HISTORIC AND DESIGN REVIEW COMMISSION

August 19, 2015

HDRC CASE NO: 2015-331
ADDRESS: 524 N PINE ST
LEGAL DESCRIPTION: NCB 1370 BLK 2 LOT 3
ZONING: RM4 H
CITY COUNCIL DIST.: 2
DISTRICT: Dignowity Hill Historic District
APPLICANT: Ceaser Gonzalez
OWNER: Ceaser Gonzalez

Historic and Design Review Commission
Design Review Committee
Report & Recommendation

SITE PLAN
SCALE : 1"=20'-0"

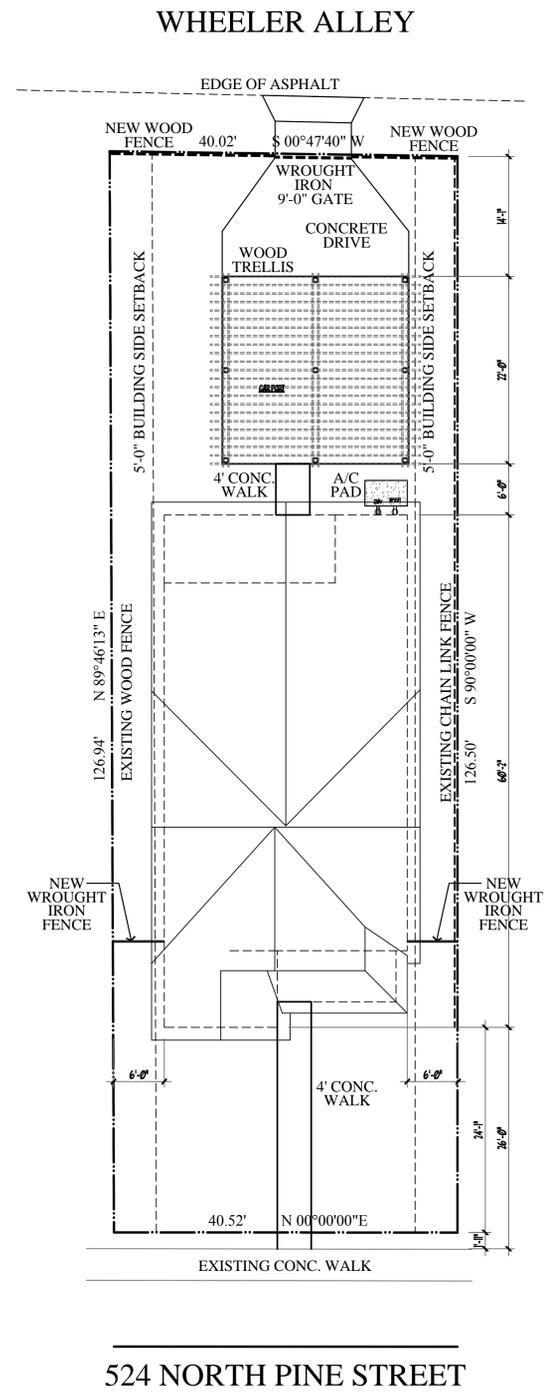
- n. A stipulation of conceptual approval was for the applicant to align the proposed carport as closely as possible to the historic setback of rear accessory structures throughout the district. At this time, the applicant has provided staff with updated information regarding this stipulation, including a site plan and feasibility study indicating carport alignment limitations.

Site Plan Study Conclusion

A site plan study was performed and options considered for rear parking access so as to align as close as possible to garage structures along Wheeler Alley.

1. Pair of 9' gates were evaluated for rear access parking and it was concluded this would not allow for adequate space required for cars to exit the carport into the alley
2. Utilization of an 18' sliding gate for rear access parking was evaluated and it was concluded an 18' gate exceeds the site limits

Conclusion: A custom made sliding driveway gate 5' tall and 9' in width was deemed the most feasible option to accommodate a rear entry two car carport sited as close as possible to the adjacent garages along Wheeler Alley.

LEFT SIDE ELEVATION
SCALE : 1/4"=1'-0"

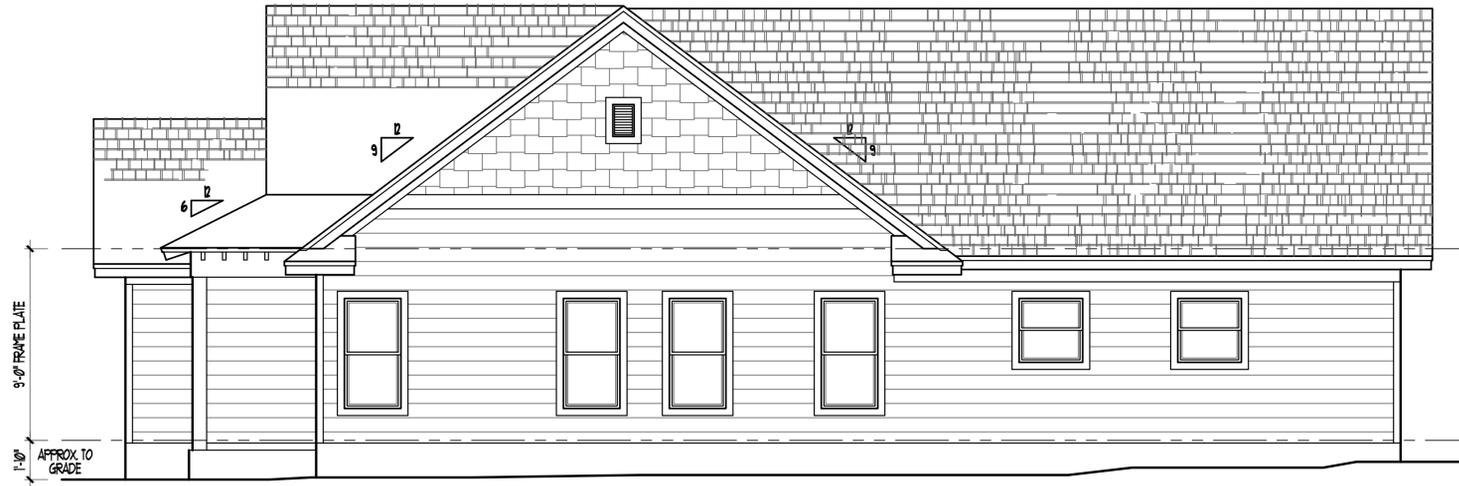
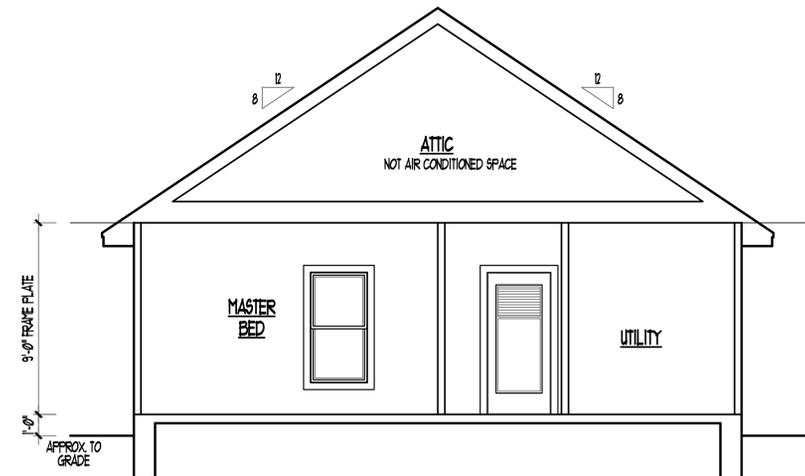
- e. According to the Guidelines for New Construction on Building Massing and Form, new buildings should have similar height, scale and roof forms consistent with nearby historic structures. The applicant has revised the proposed roofline to have a continuous ridge along the top, consistent with neighboring structures. The proposed roof design is consistent with Guidelines 2.A.i and 2.B.i.

- i. According to the Guidelines for New Construction, window and door opening should have similar proportions of wall to window space as typical with nearby historic facades. Window and door openings shall be considered similar if they are no larger than 25% in size and vary no more than 10% in height to width ratio from adjacent historic structures. In addition, large areas of blank walls should be avoided. The applicant has revised the proposed fenestration patterns with a more unified rhythm. The applicant's revised design as it pertains to relationship of solids to voids is consistent with the Guidelines, 2.C.i.

- l. According to the Guidelines for New Construction, incorporated architectural details should be in keeping with the predominant architectural style along the block face or within the district when one exists. Details should be simple in design and should complement, but not visually compete with, the character of the adjacent historic structures or other historic structures within the district. Architectural details that are more ornate or elaborate than those found within the district are inappropriate. The proposed design's gable returns are not typical to the district and are not consistent with the Guidelines for New Construction on Architectural Details 4.A.i.

COMMENTS/CONCERNS: CB - intended to do two windows vs. one w/ shutter. MB - If you're doing wood, you should look at doing all wood. BF - having an aerial might help. Show context. MB - Street elevation is appropriate. Detail for return at gable. Bulk of house has lower ridge line. Visibility of side elevation? CB - sides aren't very exposed. MB - Multiplicity of window types, play w/ sizes to make it more consistent. Look at return. Rear elevation isn't an issue. Not visible. Nicely done, good infill design.

Show context. REVISE WINDOWS - SIDE

- i. The applicant eliminates gable returns to be more consistent with architectural detailing found in the district.
- ii. The applicant provides additional information on window installation including a profile section for staff review, per finding g.
- iii. The applicant uses window and door materials consistent with the Guidelines for New Construction 3.A.i.

CARPORT/ TRELLIS - FRONT ELEVATION

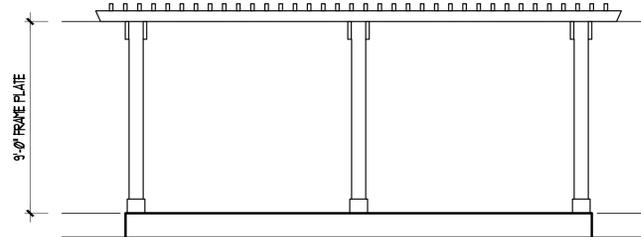
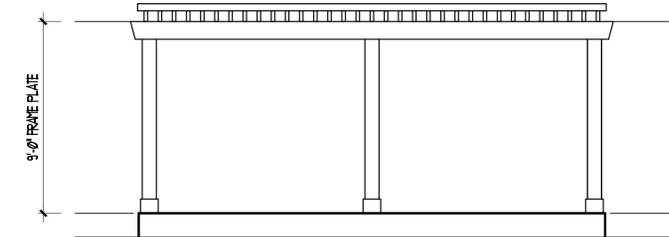
- m. The applicant request a new, approximately 484 square foot trellis carport at the rear of the property. The proposed wood trellis carport is approximately 9 feet in height. The proposed carport will have direct entry and

exit access to Wheeler Alley, consistent with neighboring garages and outbuildings. According to the Guidelines on New Construction, garages and outbuildings should be visually subordinate to the principle historic structure in terms of their height, massing, and form. New outbuildings should be no larger in plan than 40 percent of the principle historic structure footprint, and character should be related to the principle building's period of construction through use of complementary materials and simplified architectural details. The proposed wood trellis carport is consistent with the Guidelines for New Construction in terms of massing, form, building size and character.

Staff recommends approval of item #2 based on findings m and n.
